ENGINE - H.P. COMPRESSOR VARIABLE STATOR VANES - REDUCED NUMBER OF RIGGING PIN BRACKETS
- CATEGORY CODE 7 - MOD.ENG-72-0084

V2500-ENG-72-0084

Location of H.P. compressor VIGV and variable stator vane actuating mechanism
Fig.1 (Sheet 2 of 2)

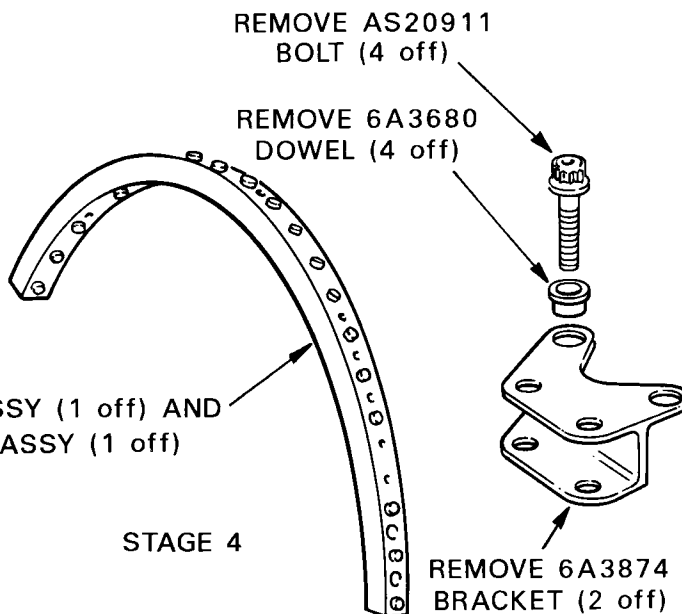
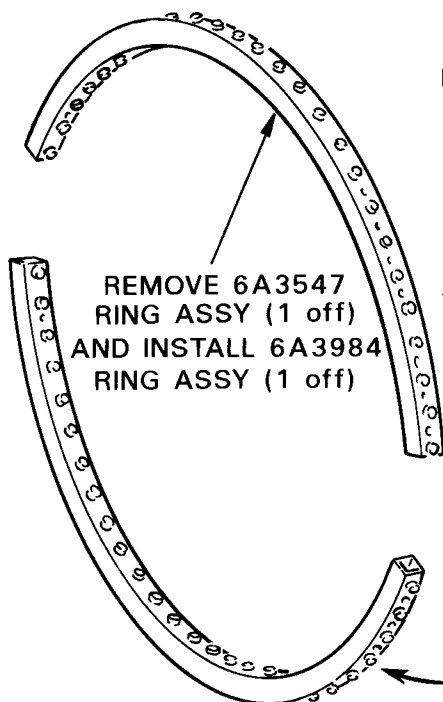
REMOVE 6A3543 RING ASSY (1 off) AND
INSTALL 6A3983 RING ASSY (1 off)

Section AG at 2 positions AF showing VIGG rig pin brackets before and after alteration
Fig.3

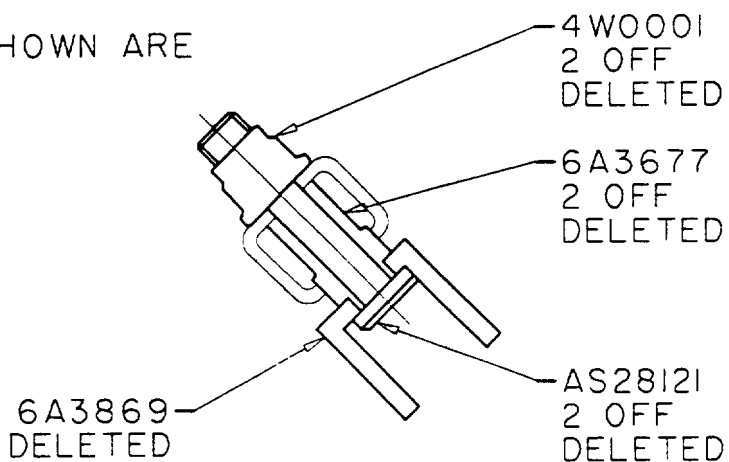
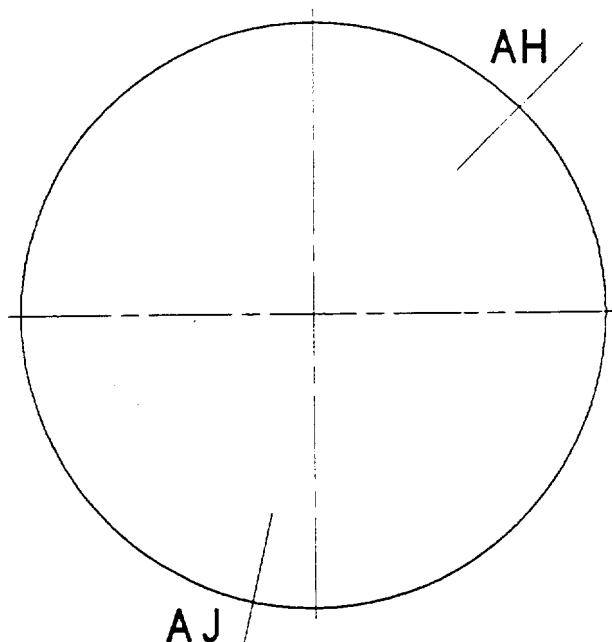
The two rigging pin brackets located on the upper half unison rings at the V.I.G.V. stage and at stages 4 and 5 are deleted. At stage 3, one bracket is deleted from each of the half rings. The associated hollow dowels and bolts for securing the brackets are no longer required.

View at AH showing rig pin bracket before and after alteration
Fig.4

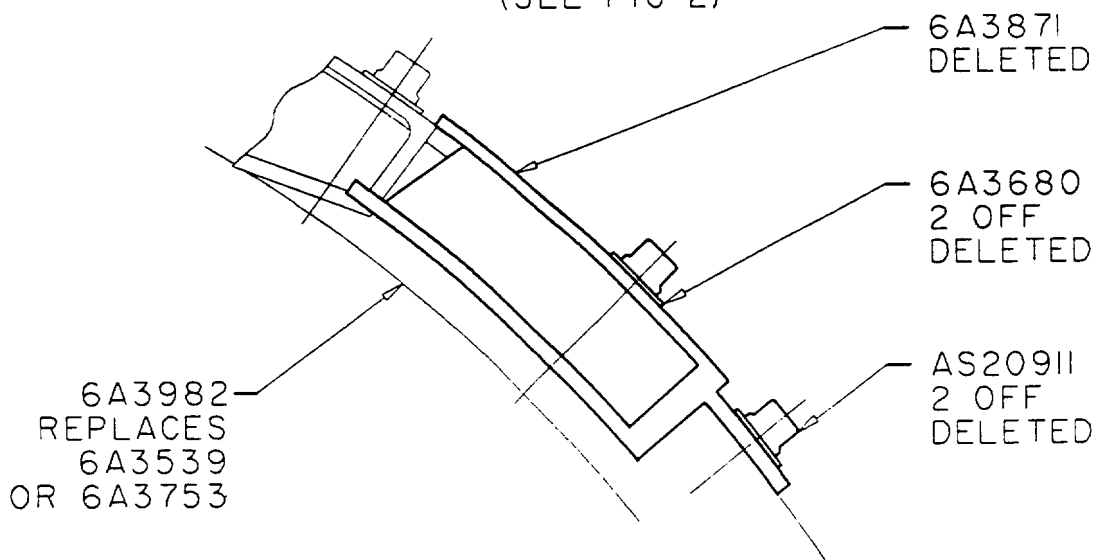
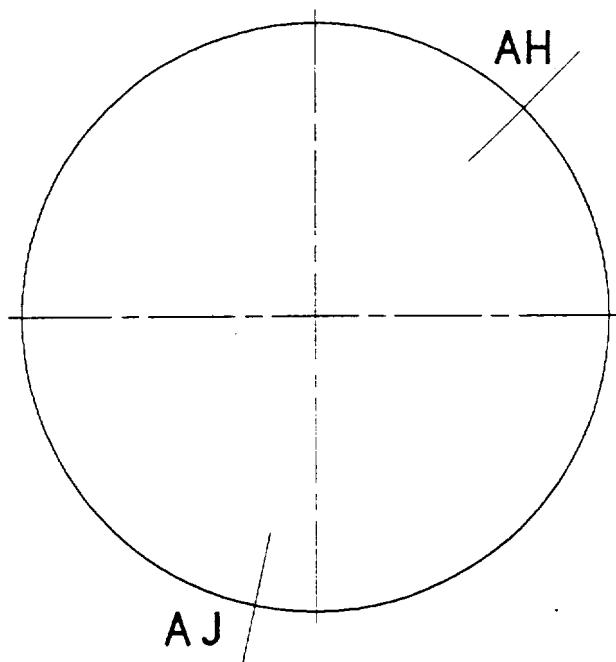
The bracket assemblies within the stages 3 and 4 unison rings which were required to retain the rigging pin bracket bolts are deleted. On the stage 5 ring the two existing brackets are replaced by shorter brackets.
